PROJECT: PLAN OF A PROPOSED ONSITE WASTEWATER TREATMENT SYSTEM
LOCATION: LOT 387 OF ASSESSORS MAP 9
OWNER: BRUCE GARDNER & OTHERS
ADDRESS: SEA LEA AVENUE
CITY/TOWN: CHARLESTOWN RI
DATE: JULY 26, 2016
SCALE: 1" = 20'
DRAWN BY: C. DOYLE
CHECKED BY: C. DOYLE
SHEET 1 OF 2

SECTION 1.1.7-VARIANCE NARRATIVE
FOR SECTIONS
1.1.9 COASTAL SETBACKS & 1.1.11 COASTAL BUFFERS
OF THE
RHODE ISLAND COASTAL RESOURCES MANAGEMENT PROGRAM
FOR
PROPOSED DWELLING
LOCATED ON MAP 9, LOT 387, SEA LEA AVENUE
IN THE TOWN OF CHARLESTOWN, RHODE ISLAND
OWNED BY/PREPARED FOR
BRUCE W. GARDNER & CHARLES A SWEET REV. TRUST

Subject: 2021-02-051/Gardner

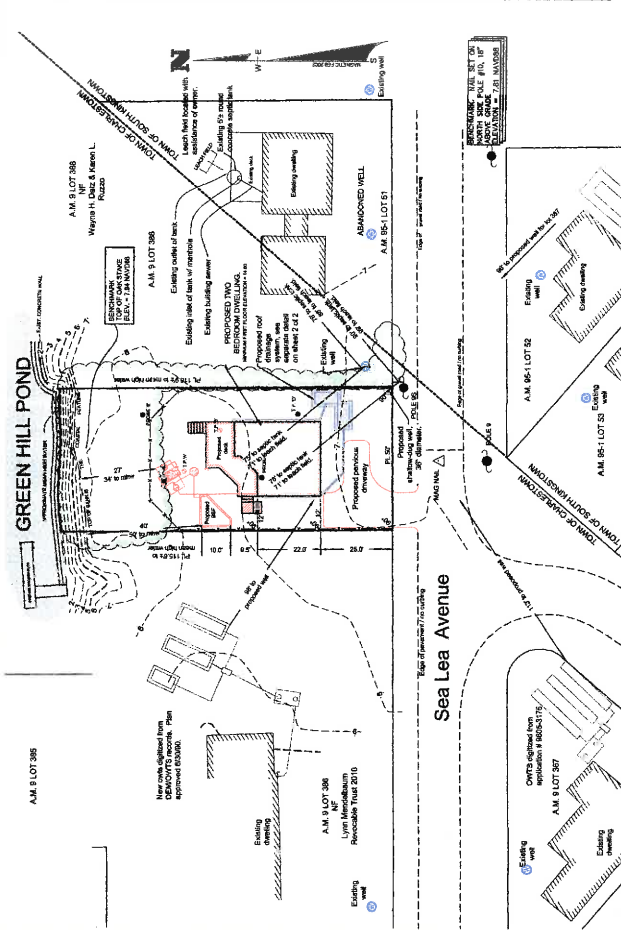
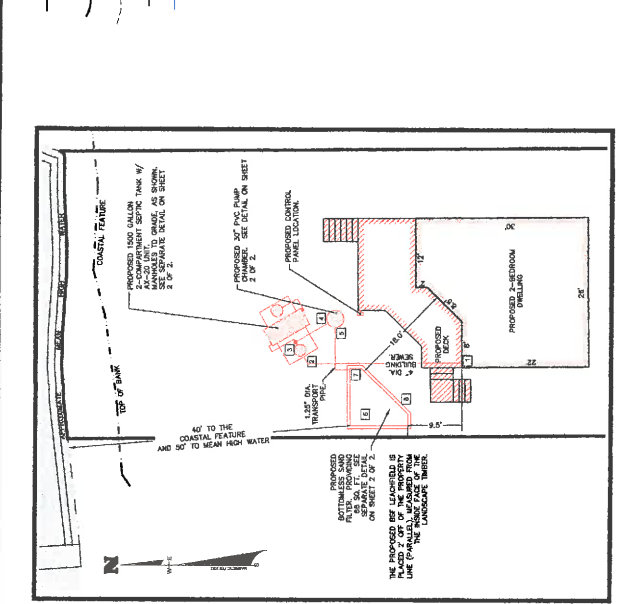
Got this resubmission in. Still need the required CHA Worksheet. The BO Sign off is for a different plan than I have and needs to be updated. The plan I've got it last revised 7/19/2018. The BO form references a 2016 plan.

Also don't have the approved OWTS plan. The plan I have is titled Plan of Proposed OWTS but does not have the DEM Approval Stamp.

The path on the plan extends onto the Coastal Feature. No vegetative alteration of the Coastal feature is allowed. Path must stop at the feature.

Looks like no revisions/minimal revisions were made between this and the deficiency. Please address how 2' setback between the OWTS and vegetated buffer is sufficient – this is narrower than a typical lawnmower and will be nearly impossible to maintain. CRMC typical minimum setback is 10'.

There is no grading shown for the installation of the OWTS and the OWTS extends beyond the LOD. Please address and revise accordingly.

Did the applicant request front setback relief? Looks like the dwelling is at the standard front setback.

- The required Town of Charlestown setbacks from the property lines are: 30' in the front, 38' in the rear, and 12' on the sides. No zoning relief has been obtained from the Town of Charlestown since the proposed house as located on the proposed site plan is consistent with the setback from the street of the abutters' houses. The house for the abutter to the east is approximately 20' from the front property line and house for the abutter to the west is approximately 39' from the front property line. We note that both the abutters to the east and west of the site have considerably larger lots (approx. 0.36 acres in size for the westerly abutter and 0.23 acres for the easterly abutter whose lot is approximately split in half by the Charlestown/South Kingstown town line). The minimal side yard setback of 12' leaves little room to ask for any relief in that direction and still provide for access to the rear yard or for maintenance activities on the proposed house.

- The 2' setback provided will allow for the continued maintenance of the OWTS following construction as 2' on the north side of the tank is adequate for a person to access the septic tank and AX-20 filter or to use a weedwacker to cut grass.

- The 50' required setback from the septic tank and leach field to the coastal feature cannot be met. 27' to the septic tank and 40' to the bottomless sand filter type of leach field has been approved by DEM in lieu of the 150' setback required at the time of DEM OWTS submission.
